## Accessibility Survey

## 11th Street - Brookshire Avenue to Birchdale Avenue

Brookshire Avenue to Birchdale Avenue  
Downey, CA 90242

Date of Inspection  
7/14/2017

**Southeast Corner of Brookshire Avenue @ 33.949148434999, - 118.122264146805**

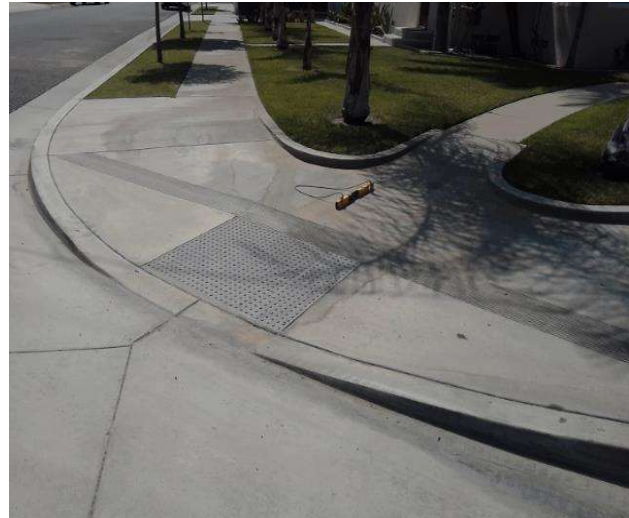
Curb Ramp , Landings and Transitions : Top Landing Slope

**Finding**

The slope at the top landing is greater than allowed.

**On-Site Finding** 3.80 percent

Provide a top landing surface that does not exceed the maximum slope and cross slope. Provide a sufficient maneuvering clearance that does not accumulate water.

Recommendation Up to 2.08 percent
